Re: **RESPONSES TO FIRST REVIEW – ILIFF STATION MULTI-FAMILY SITE PLAN MINOR AMENDMENT**
CASE NUMBER: 2015-4005-02

Enclosed herein is the second submittal for the Iliff Station Multi-Family Site Plan Minor Amendment. The comments that were provided February 13, 2018 have been addressed and are included with this letter.

SITE PLAN - SUBMITTAL
AURORA, COLORADO

2 MONUMENT B

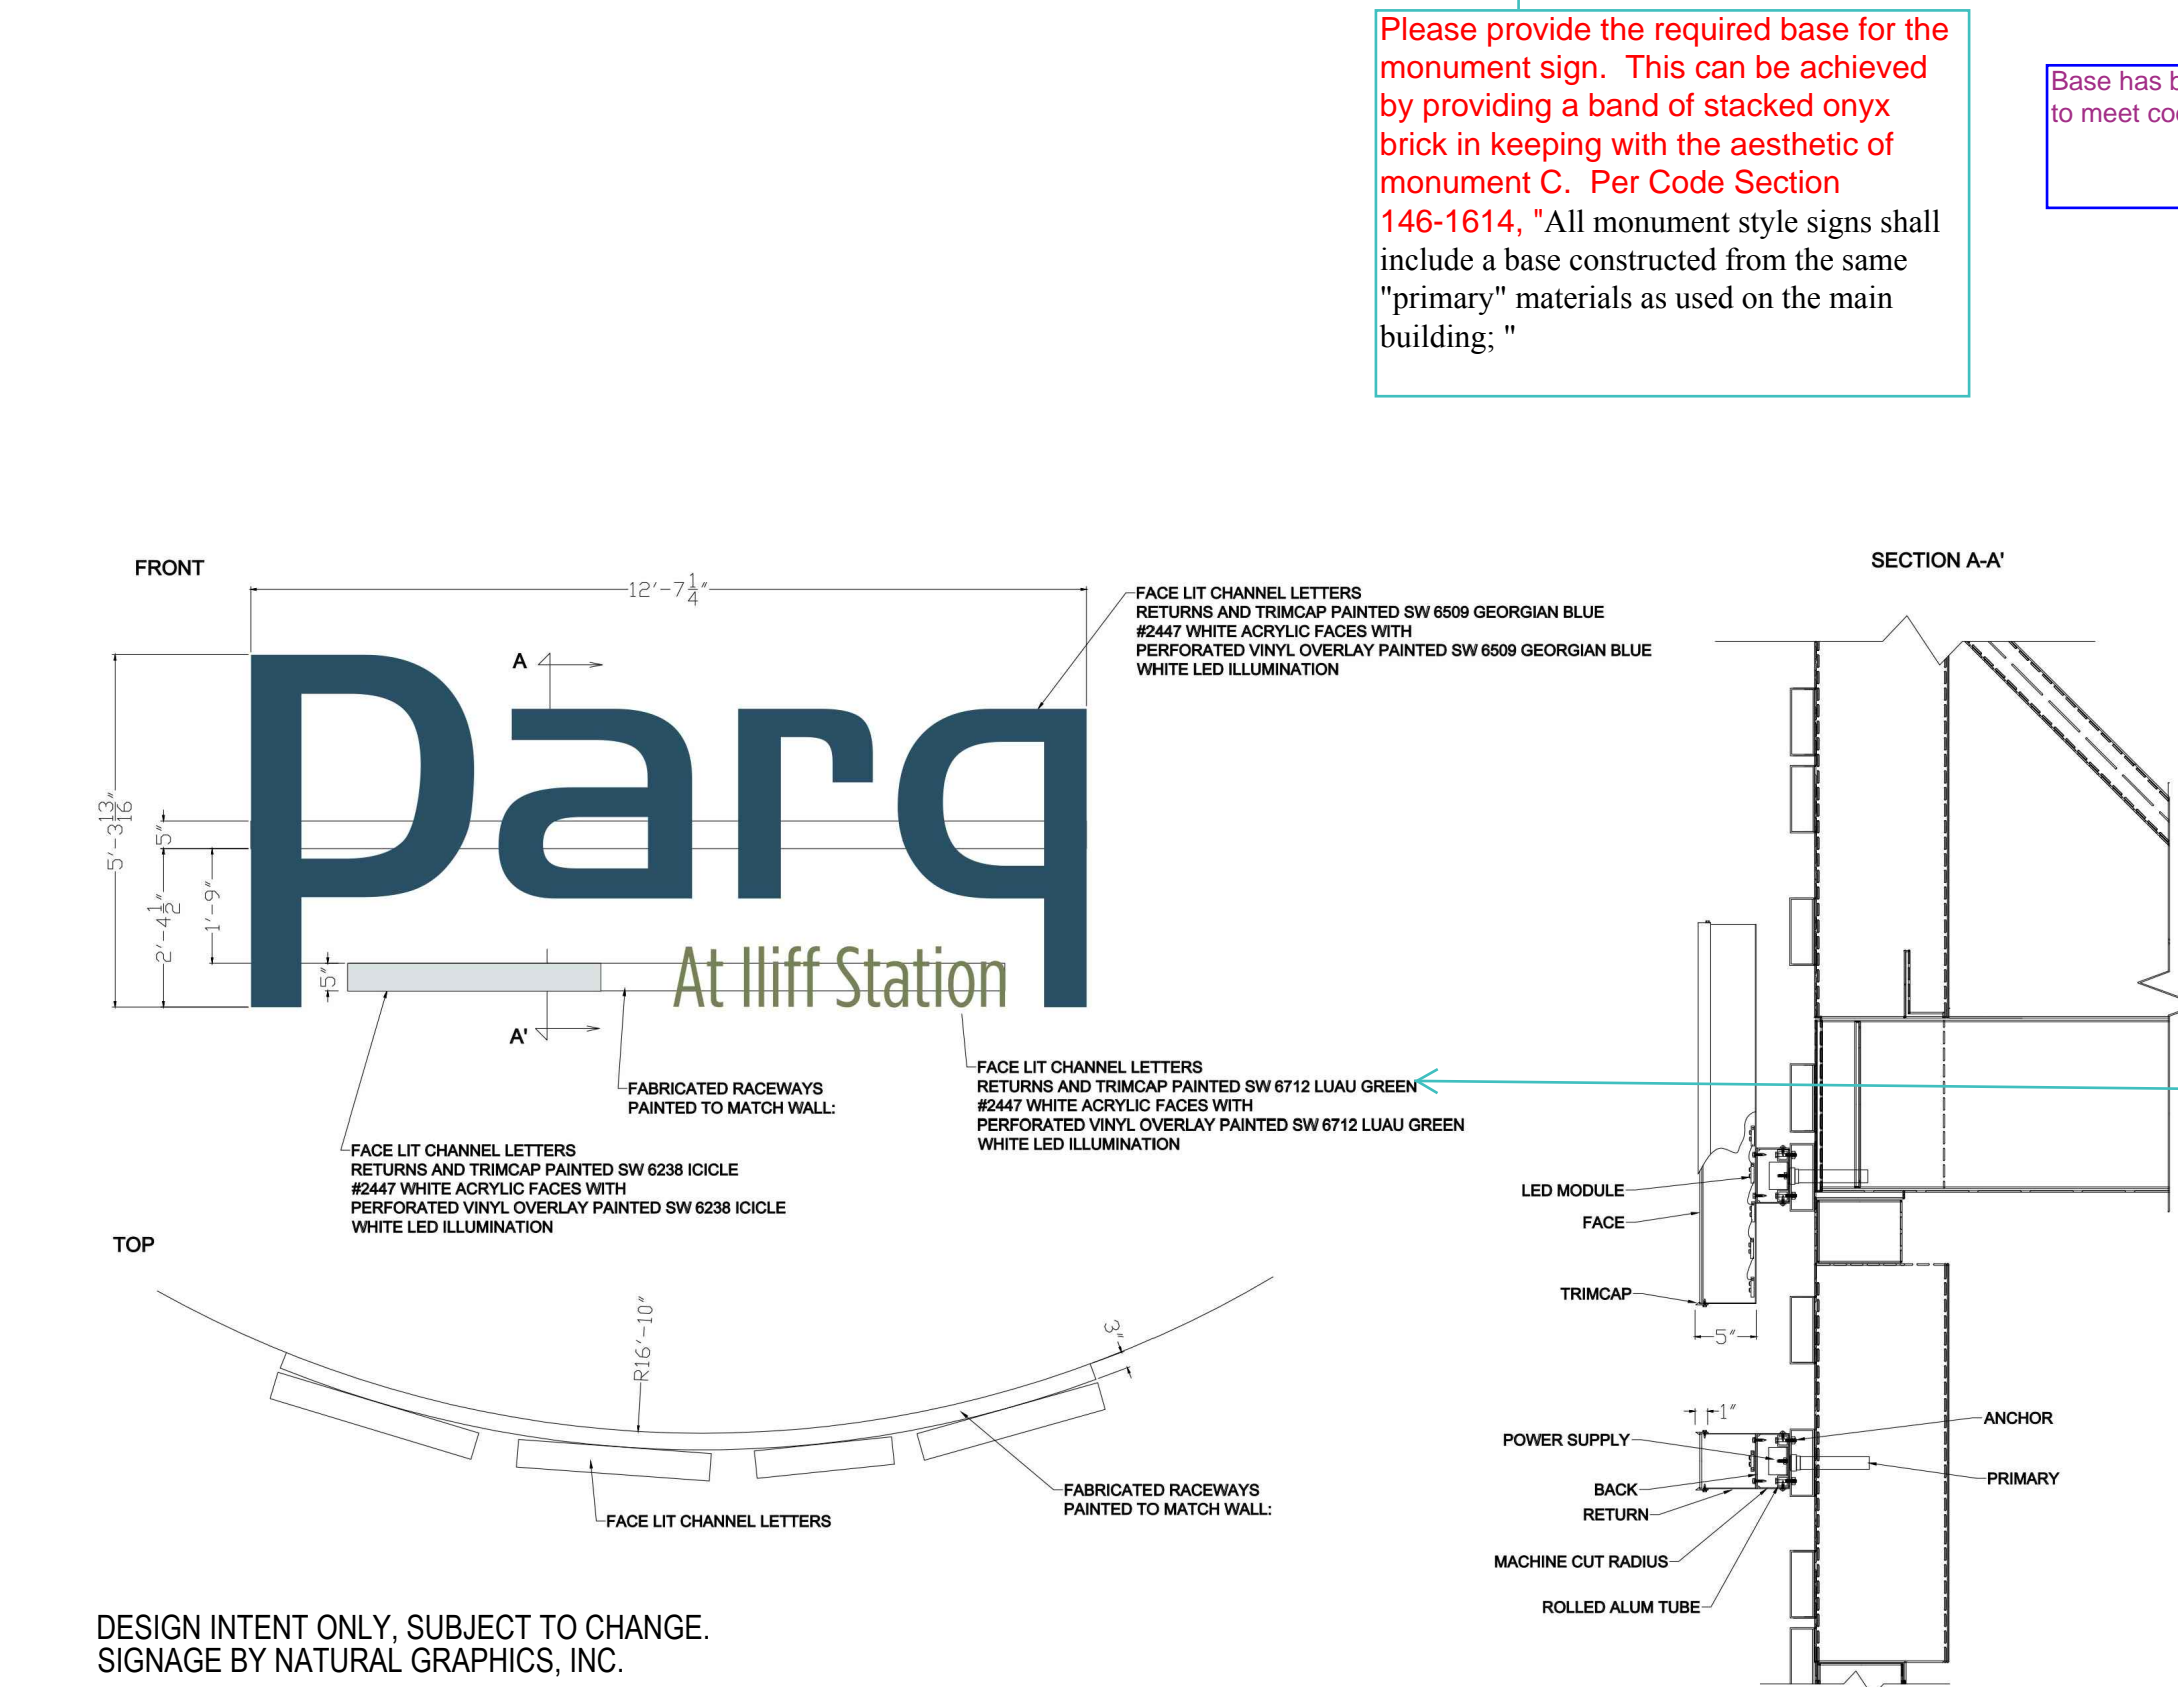
- Please indicate if Monument C Sign and Monument B Sign are two-sided.

- Please provide the required base for Monument B Sign. This can be achieved by providing a band of stacked onyx brick in keeping with the aesthetic of Monument C Sign. Per Code Section 146-1614, "All monument style signs shall include a base constructed from the same "primary" materials as used on the main building."

indicate if sign is
two-sided

Please provide the required base for the
monument sign. This can be achieved
by providing a band of stacked onyx
brick in keeping with the aesthetic of
monument C. Per Code Section
146-1614, "All monument style signs shall
include a base constructed from the same
"primary" materials as used on the main
building."

Response: Monument C and B are both two-sided. This has been added to the Data Table and the details.

Response: The required base has been provided.

details indicate is signs
are single or double
sided.

Base has been revised
to meet code.

4 WALL SIGN D - REFER TO SHEET C-2 AND ARCH FOR LOCATION

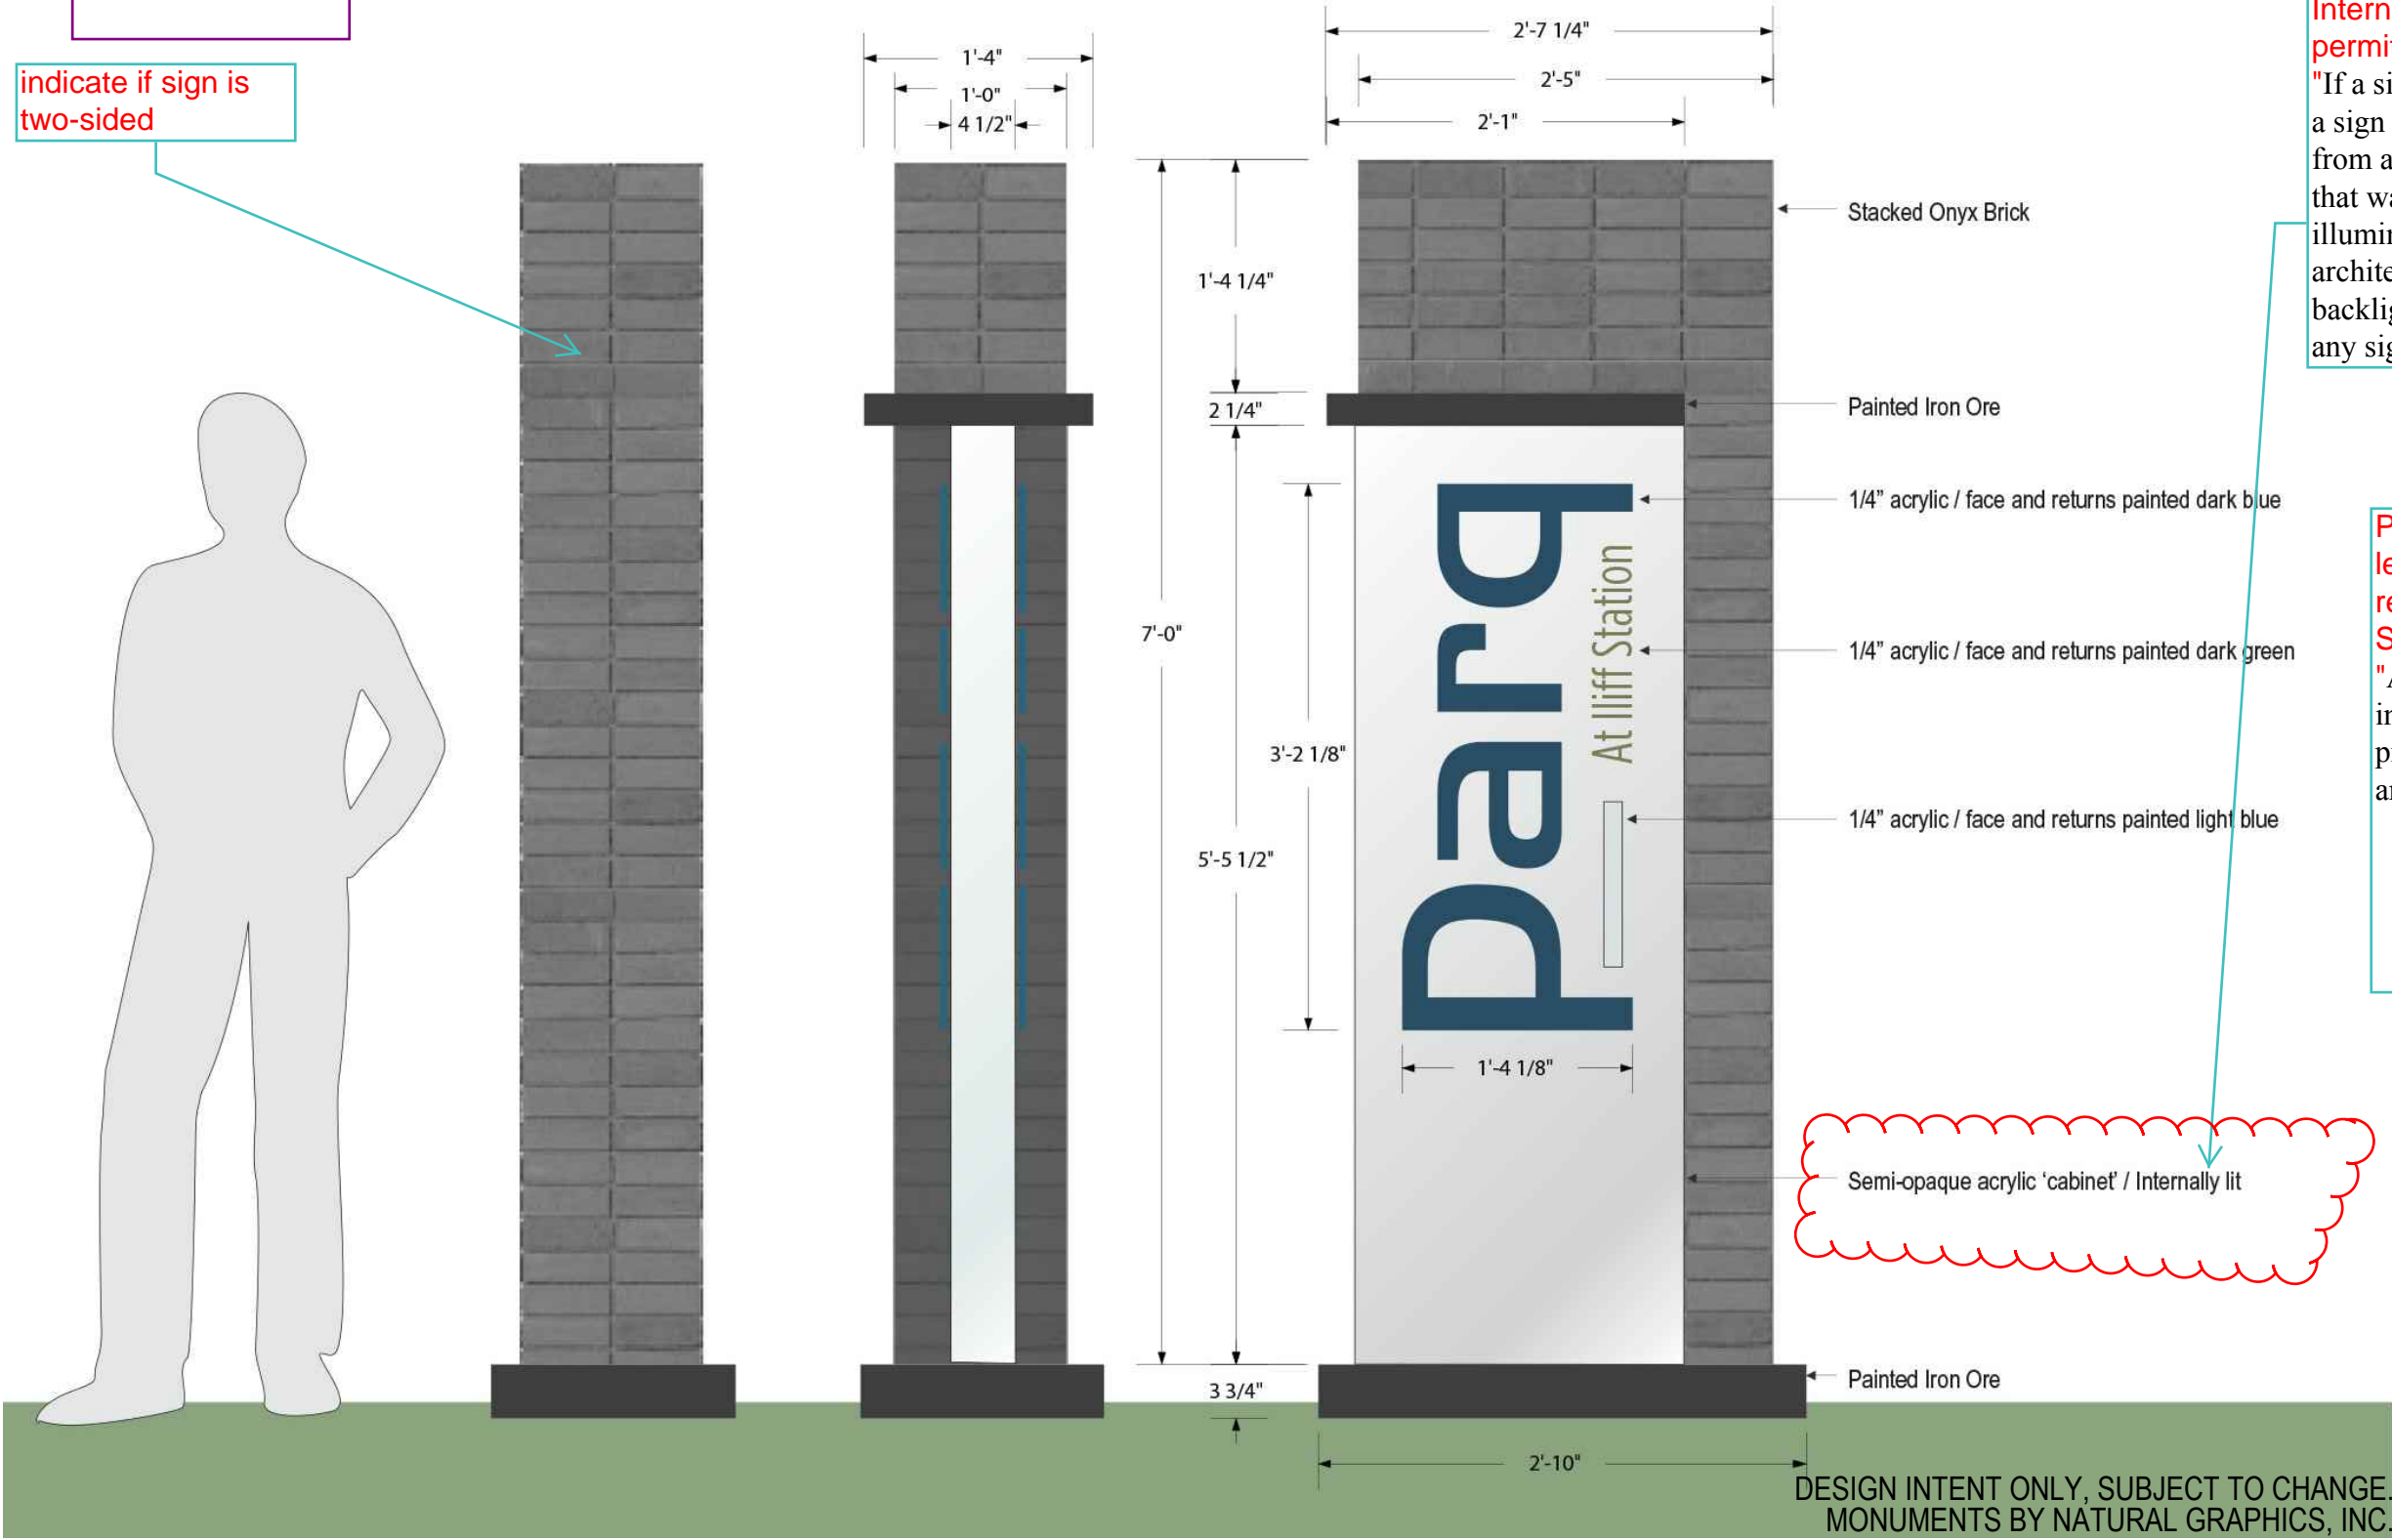
- The proposed wall sign is defined as a Project Identification Sign in code. Please ensure it is labeled as such on all sheets. In addition, per Code Section 146-1614, the maximum allowed sign area for Project Identification signs is limited to 40 square feet. This sign is showing an area of over 60 square feet. Please reduce the sign area by 20 square feet in order to comply with zoning code provisions.

Per Code Section
146-1614, the
maximum allowed
sign area for
project
identification signs
is limited to 40
square feet. This
sign is showing an
area of over 60
square feet.
Please reduce the
sign area by 20
square feet.

Response: The sign name has been revised. The sign has been reduced in size.

The sign has been
reduced in size.
